Genesis Solar Energy Project - Docket Number 09-AFC-8

Minor Changes to the Genesis Solar Energy Project Description

**6-pole Extension of Transmission Line
Inclusion of Distribution and Telecommunications Line
Removal of “Toe” Area from Plant Facility**

Submitted by Genesis Solar, LLC
Dated May 21, 2010

Figure 3

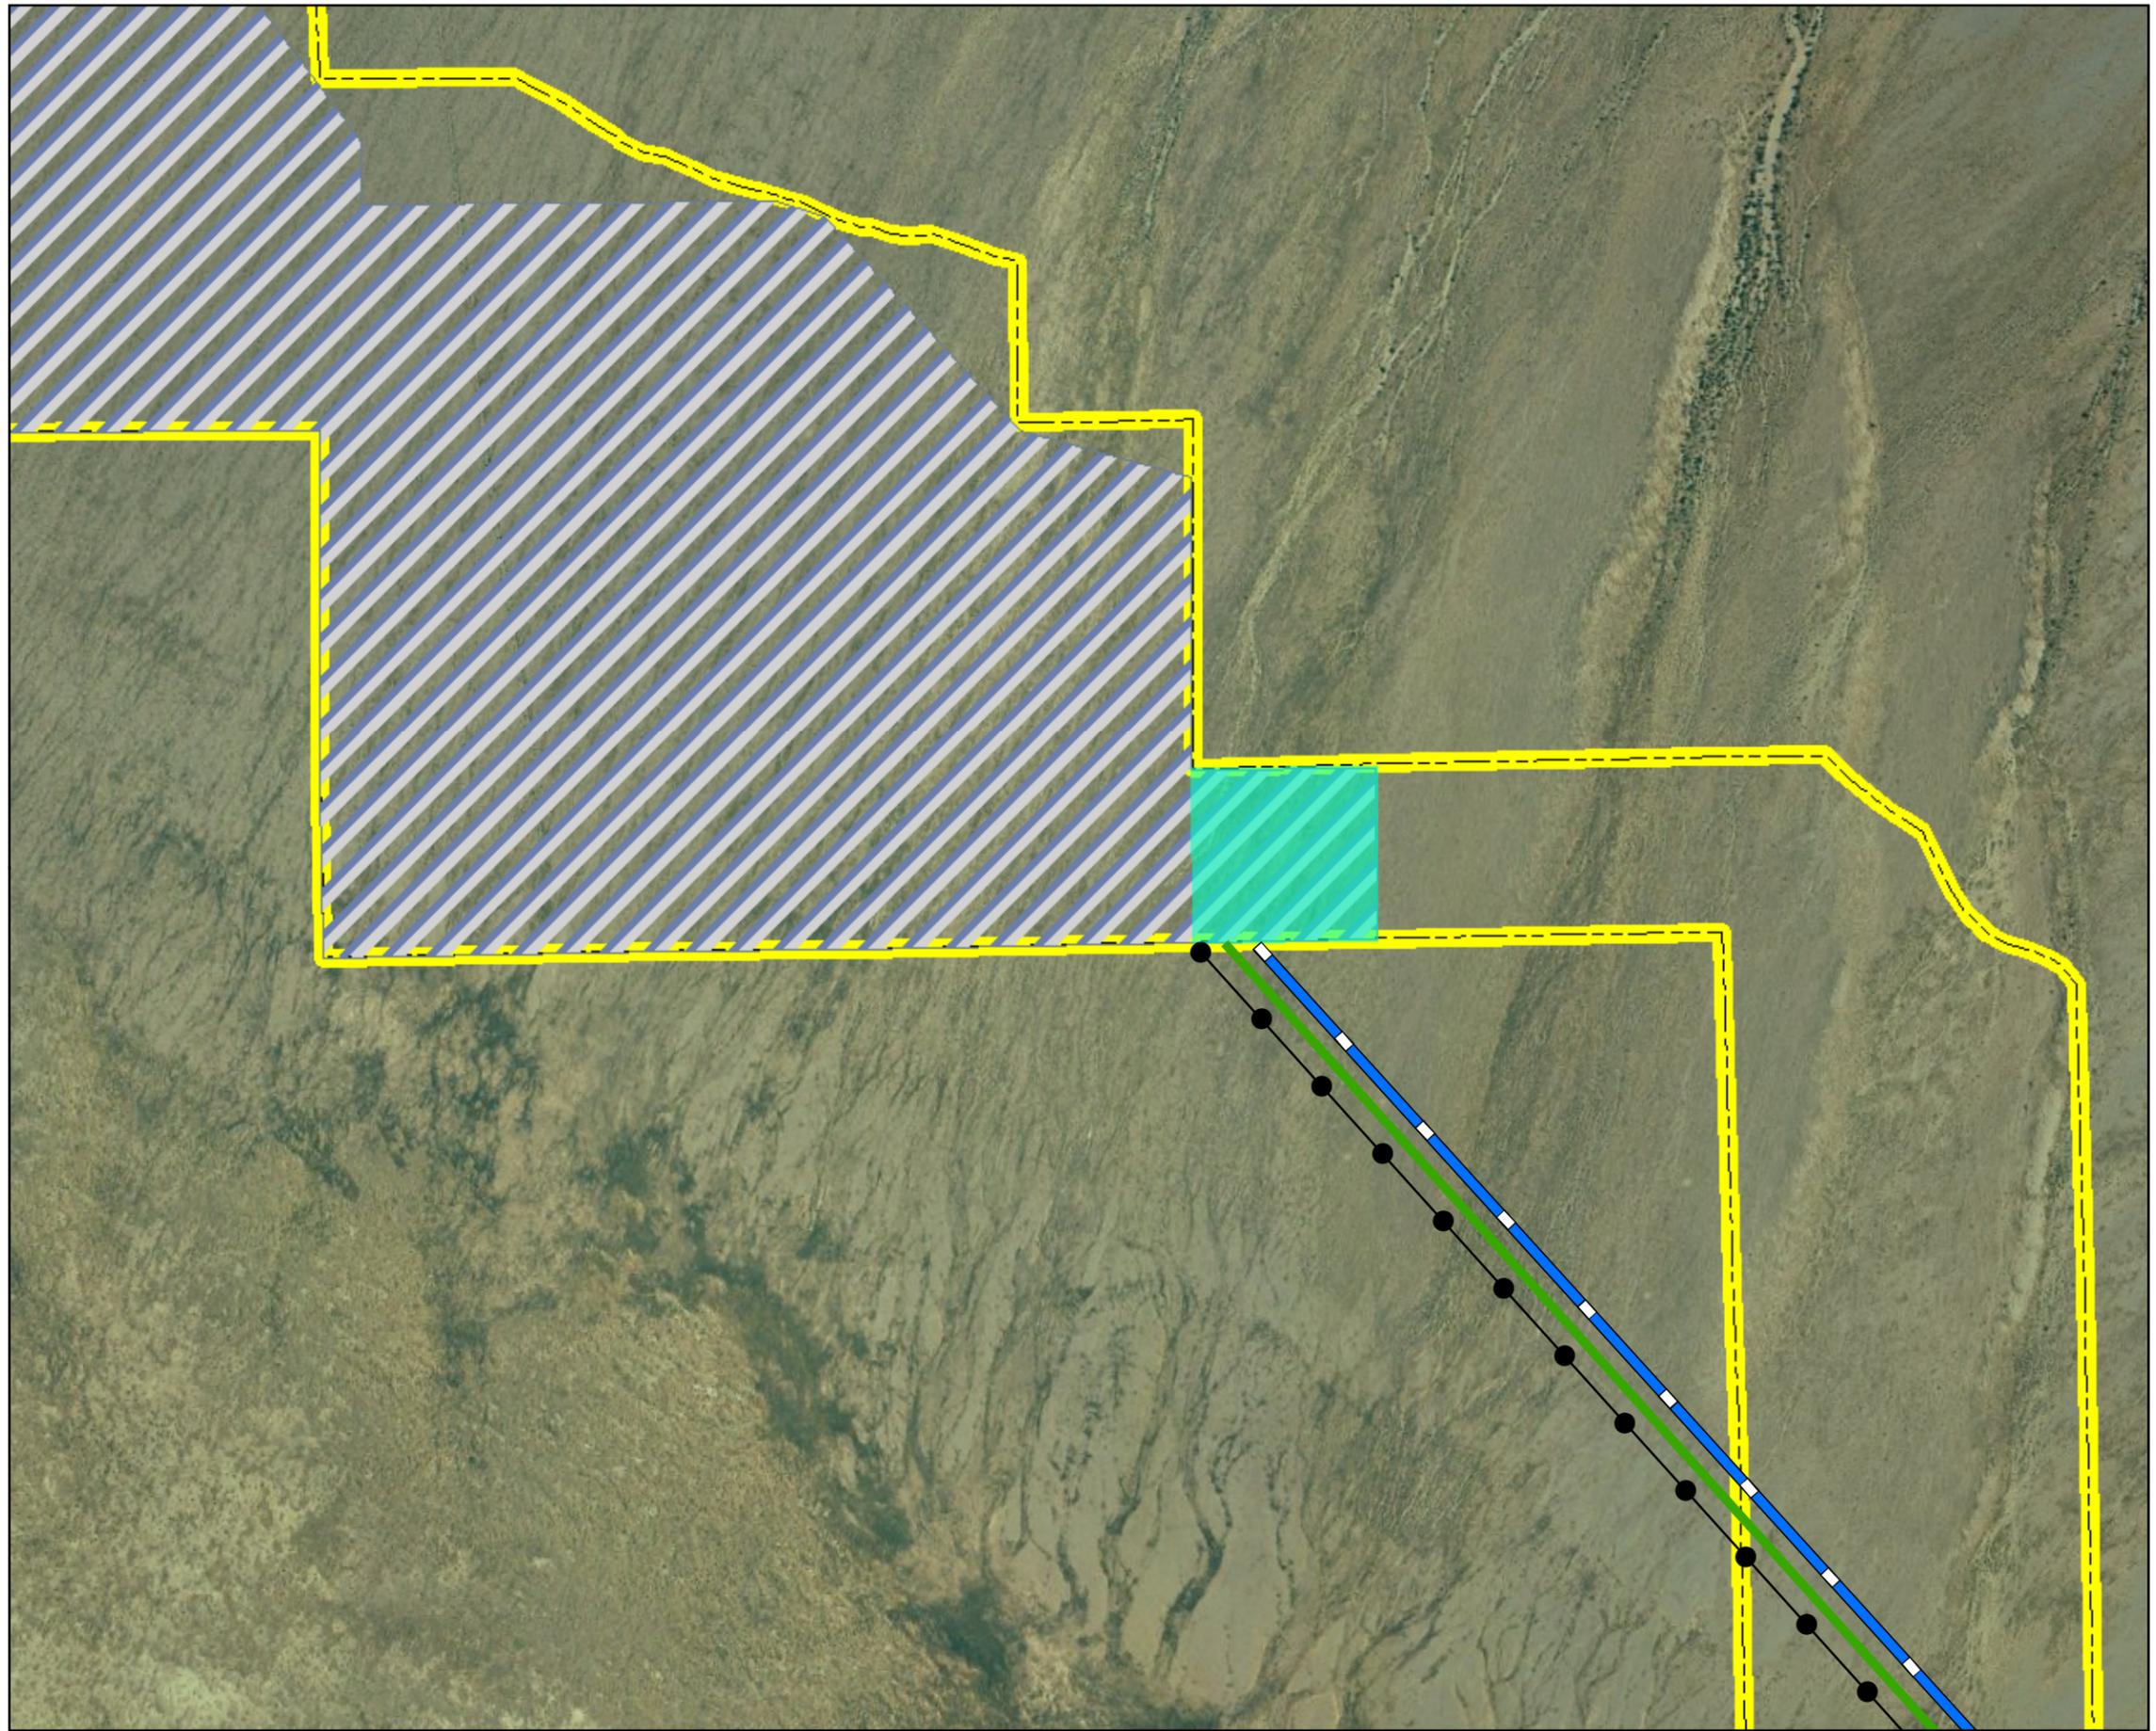
During a CEC workshop for the Genesis Solar Energy Project at the BLM office in Palm Springs, California on May 5th, 2010, the idea of not using the "toe" of the Genesis plant facility was discussed. (See Figure 3 attached) The proposal to remove the toe as part of the active plant facility would minimize or negate some potential environmental impacts, primarily due to the presence of sand dunes and habitat for the Mojave fringe-toed lizard. Additionally, the toe area has several drainage washes running through it. Genesis Solar, LLC agreed to

remove the solar troughs and other plant facilities from the toe area, and to reconfigure the plant design to accommodate the change.

The toe removal reduces 41.4 acres of potential disturbance in sensitive habitat. Of that number, 27.2 acres are identified as sand dunes, with 14.2 acres as creosote bush scrub. The CEC, BLM and staff from U.S. Fish and Wildlife Service, and the California Department of Fish and Game consider this a positive project contribution to avoiding, reducing and minimizing impacts.
